RESIDENTIAL DEVELOPMENT

8 Forest Road | Warriewood NSW 2102

SECTION 4.56(4) APPLICATION

SECTION 4.56 CHANGE LIST ADDENDUM (07/05/2024)

ADDENDUM
Drawing Title: GYM & POOL Detail
Gym & Pool Sections

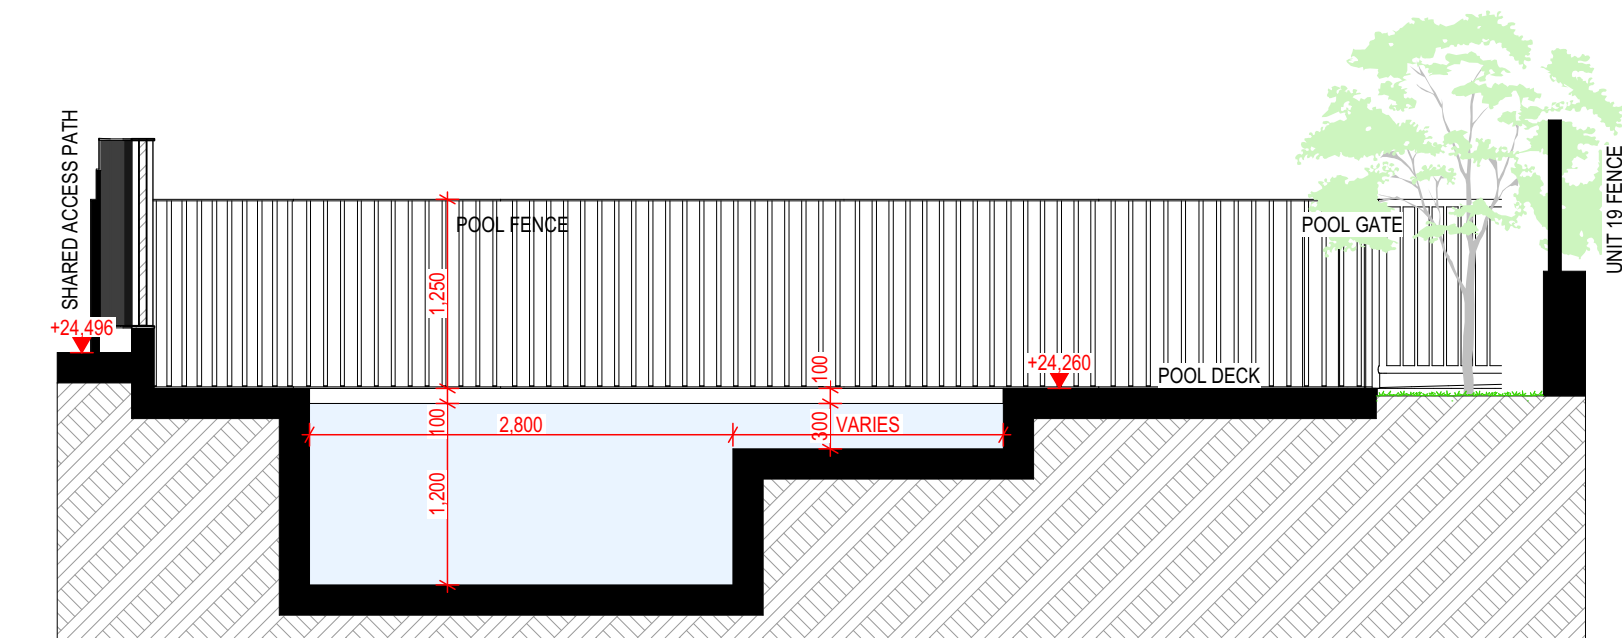
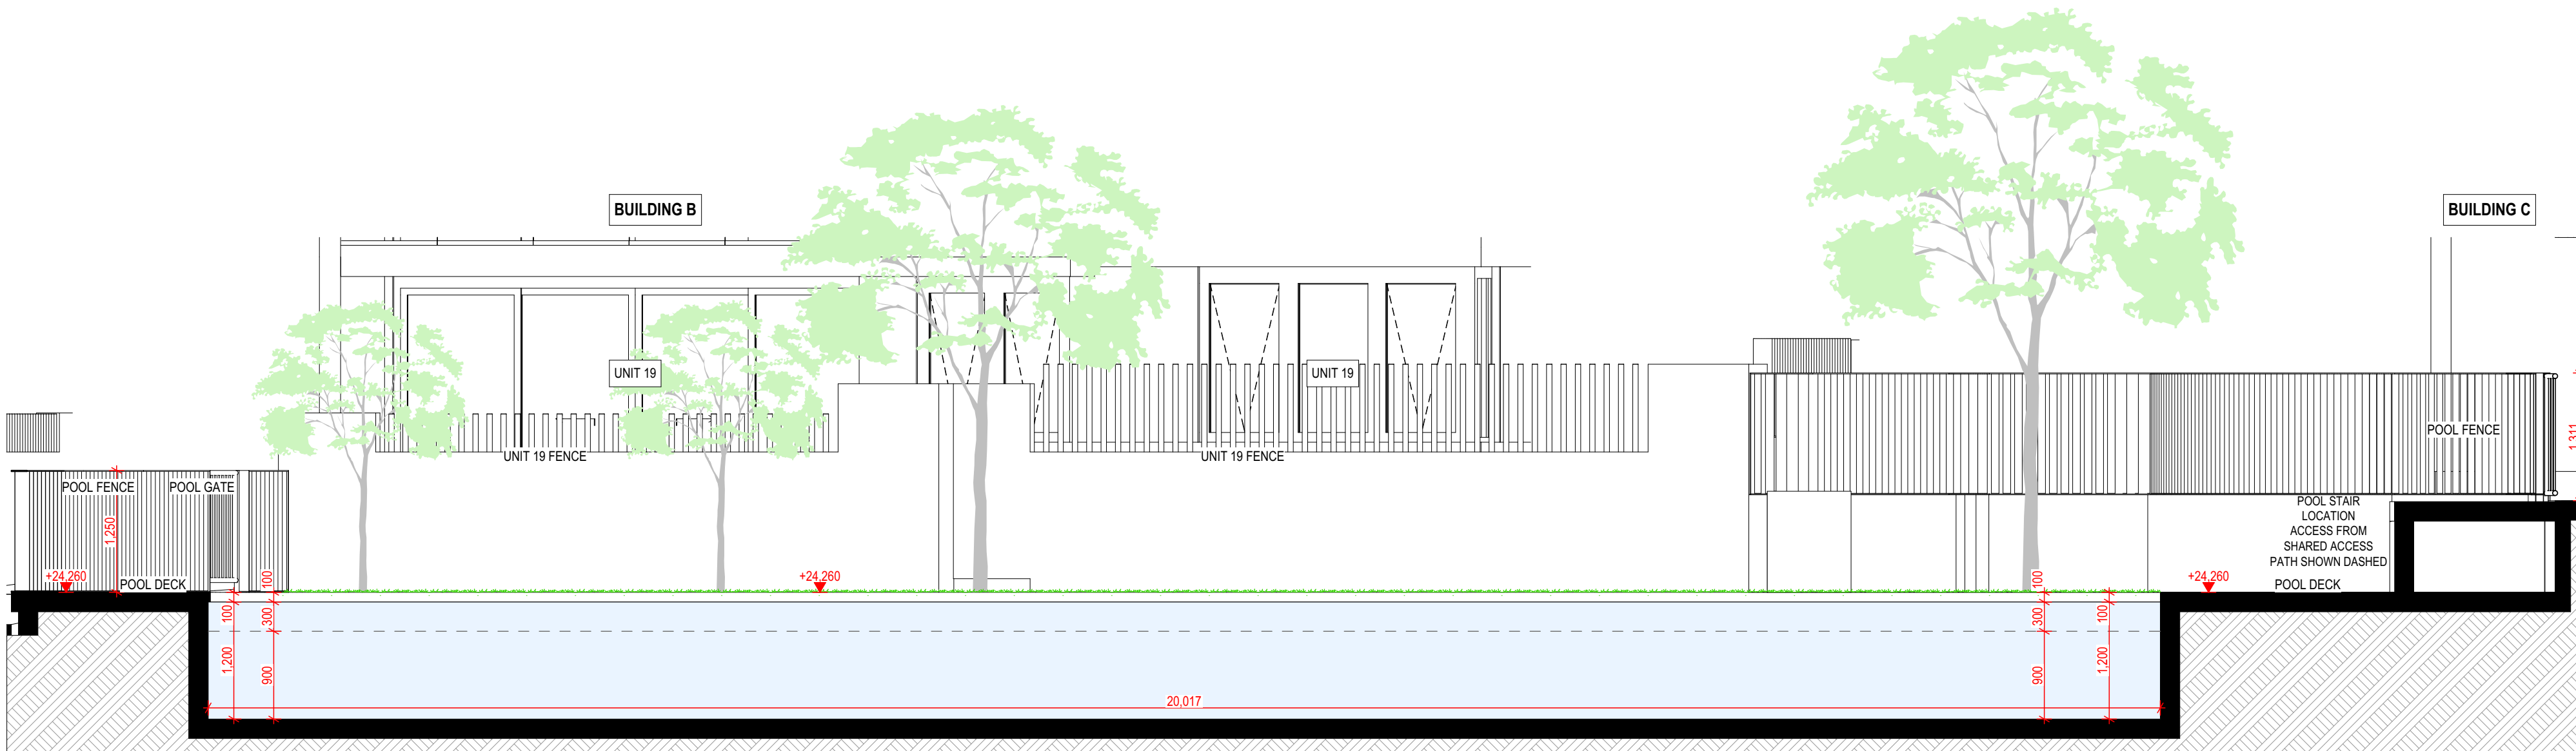
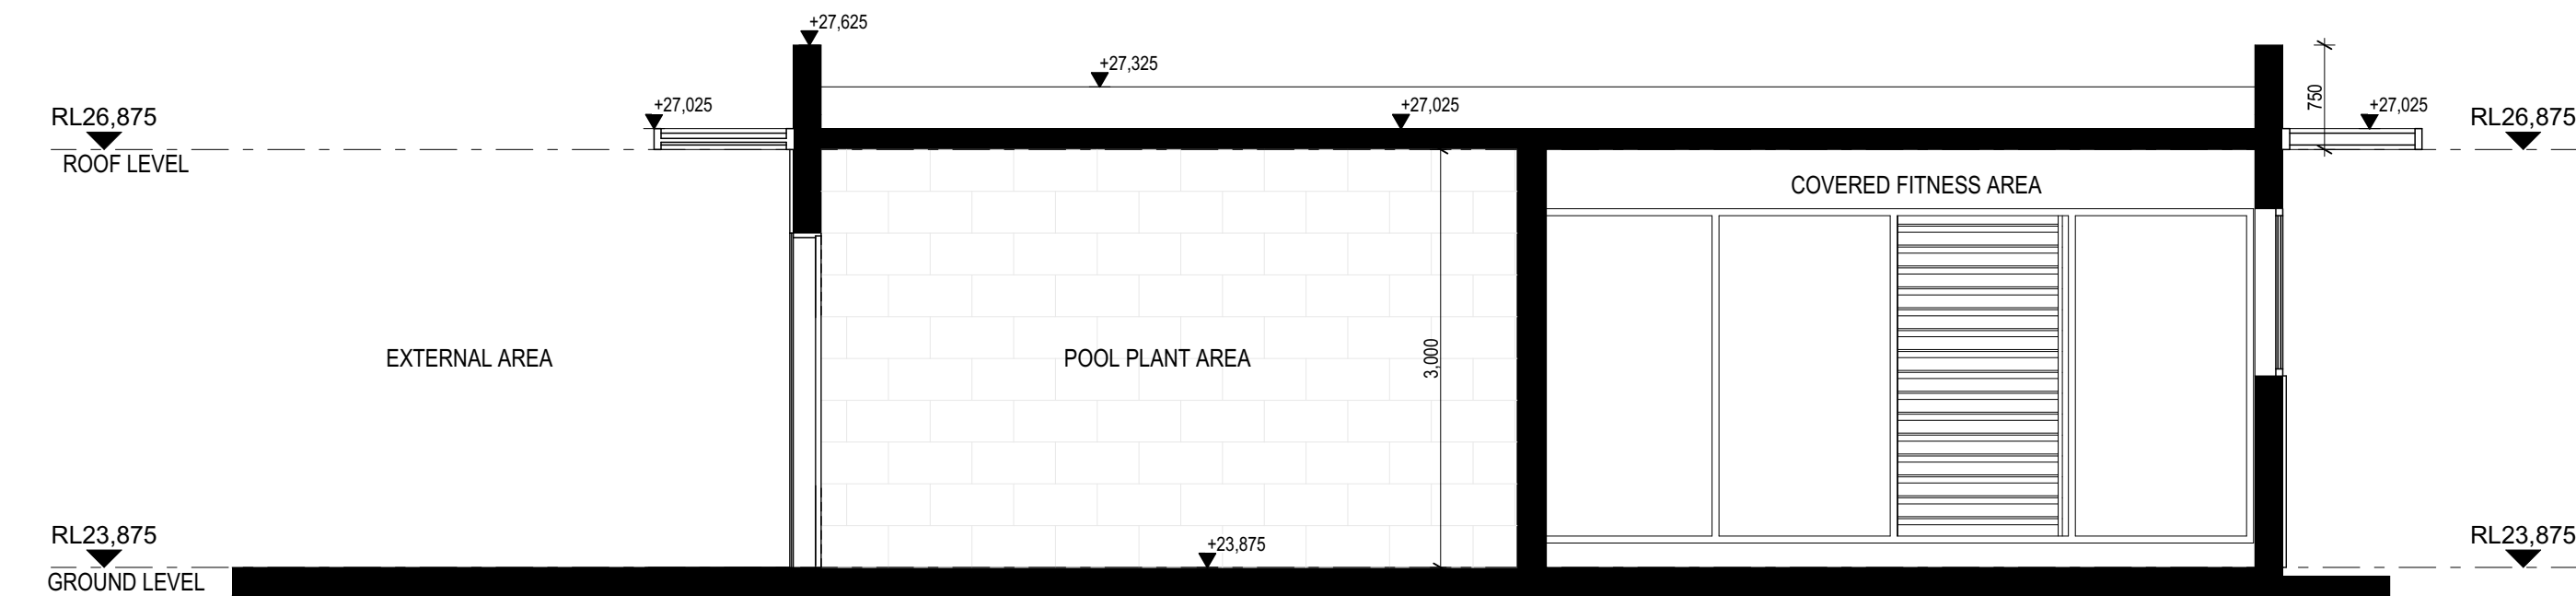
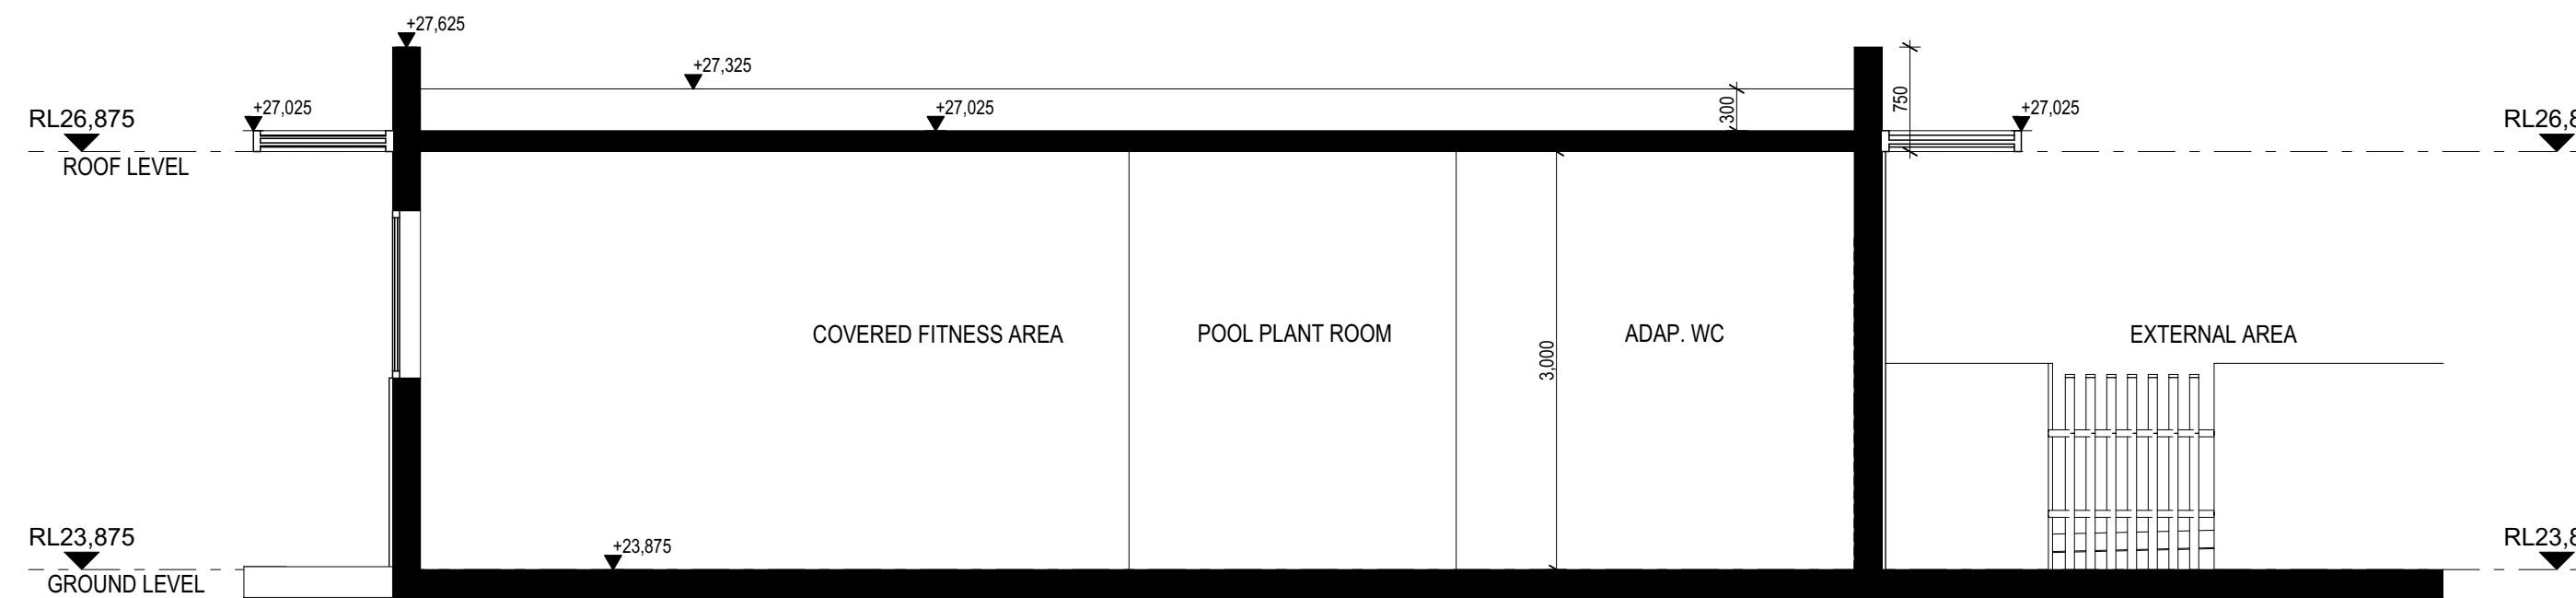
- RETURNED APPLICATION (22/11/2023)**
5. ADDITIONAL POOL SECTIONS
 6. SHADOW DIAGRAMS
- SECTION 4.56 CHANGE LIST ADDENDUM (07/05/2024)**
(REFER TO CHANGE SCHEDULE FOR MORE DETAILS)
7. INTERNAL FITOUT CHANGE INTO LIFT SPACE
 8. LIFTS REMOVED FROM TOWNHOUSES 02, 03, 04, 05, 08, 09, 10, 11, 12, 13 & 14.
 9. FINISH CHANGES, "TIMBER LOOK" CHANGED TO "DULUX DURALLOY ANOTEC MID BRONZE MATT" AND "SANDSTONE CLADDING" CHANGED TO "SANDSTONE LOOK"
 10. FACADE FINISH DRAFTING ERROR CORRECTIONS
 11. LIFT OVERRUN REMOVED & ALLOWANCE FOR ROOF PARAPET ADDED, THE HEIGHT OF WHICH IS 100mm LOWER THAN THE PREVIOUSLY APPROVED LIFT OVERRUN HEIGHT.
 12. INTERNAL FITOUT CHANGES TO UNIT 12 TO COMPLY WITH NDIS REQUIREMENTS

SECTION 4.56 CHANGE LIST (28/07/2023)
